RE: Preliminary Plan #04105-A
Roberts Landing

We have completed our review of the amended preliminary plan dated June 16, 2005. This plan was reviewed by the Development Review Committee at its meeting on July 18, 2005. We recommend approval of the plan subject to the following comments for proposed Pilots Landing Way:

SUBJECT: Plan # 1-04105A, Name Roberts Landing
DRC date: Monday, July 18, 2005

SUBJECT: Stormwater Management Concept Plan/Floodplain Review
Preliminary Plan 1-04105 ; Roberts Landing
Subdivision Review Meeting July 18, 2005 SWM File # 211471

LOTS 30 AND 31 EXHIBIT
ROBERTS LANDING - PHASE II

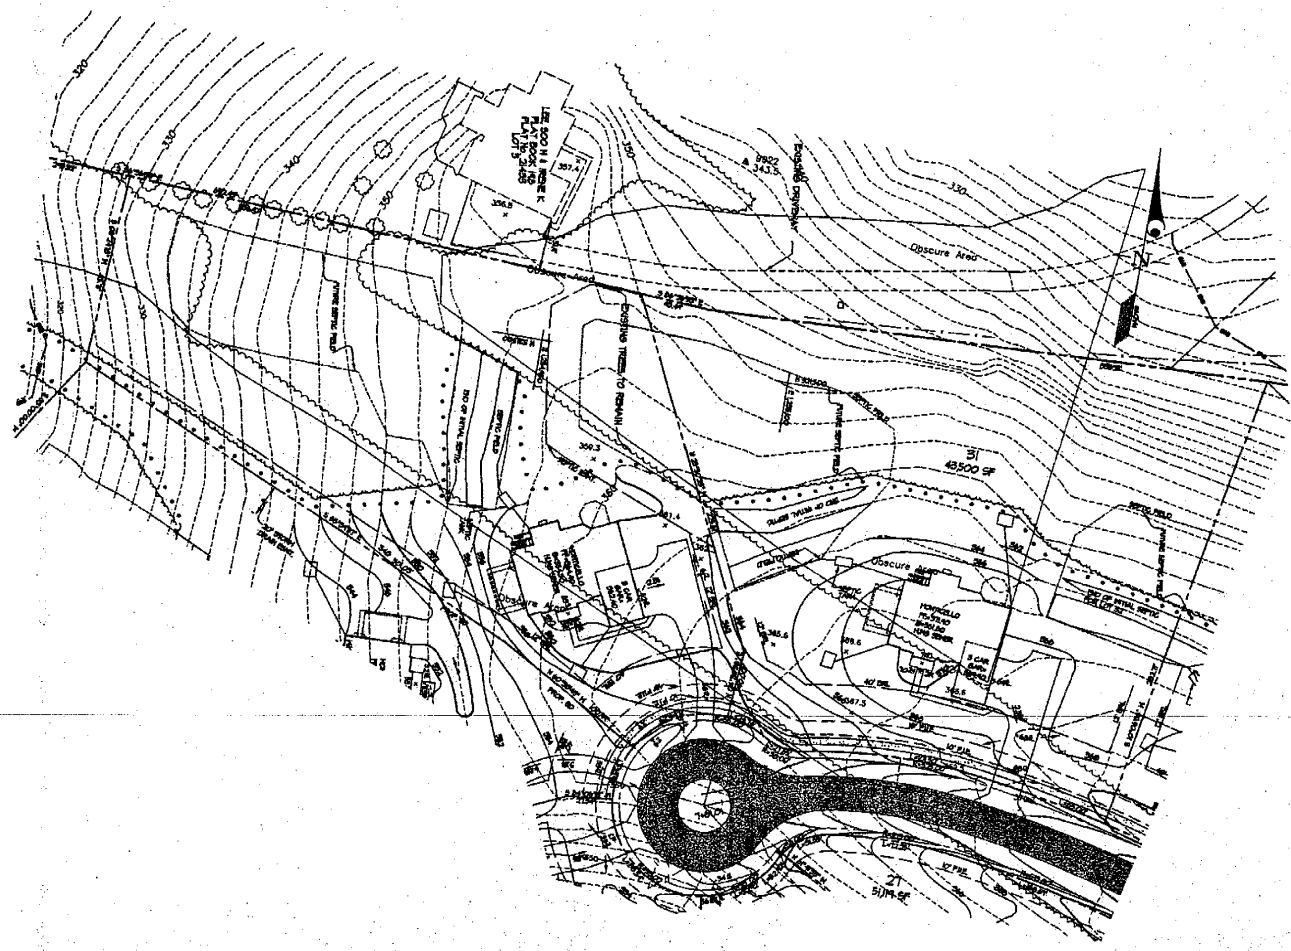
1. Previous comments in our November 5, 2004 letter for the original preliminary plan remain applicable unless modified below.
2. Full width dedication and construction of proposed Pilots Landing Way as an open section tertiary residential street.
3. Grant necessary slope and drainage easements. Slope easements are to be determined by study or set at the building restriction line.
4. Grade establishments for all new public streets and/or pedestrian paths must be approved prior to submission of the record plat.

5. A Public Improvements Easement will be necessary along Pilots Landing Way, in order to accommodate the required sidewalk construction. Prior to submission of the record plat, the applicant's consultant will need to determine if there is sufficient right of way to permit this sidewalk or execute a Declaration of Public Improvements Easement document. That document is to be recorded in the Land Records of Montgomery County, with the liber and folio referenced on the record plat. The widths of the Public Improvements Easement and the overlapping Public Utilities Easement are to be in accordance with those detailed on DPWT Standard No. MC-210.05.

6. Size storm drain easement(s) prior to record plat. No fences will be allowed within the storm drain easement(s) without a revocable permit from the Department of Permitting Services and a recorded Maintenance and Liability Agreement.

The limits of the floodplain and the building restriction lines are to be shown on the plan where applicable. The floodplain is to be dimensioned from the property line.

7. Wells and septic systems cannot be located within the right of way nor slope or drainage easements.

8. Waiver from the Montgomery County Planning Board to delete sidewalk on a tertiary classification roadway.

9. Trees in the County rights of way - species and spacing to be in accordance with the applicable DPWT standards. A tree planting permit is required from the Maryland Department of Natural Resources, State Forester's Office [(301) 854-6060], to plant trees within the public right of way.
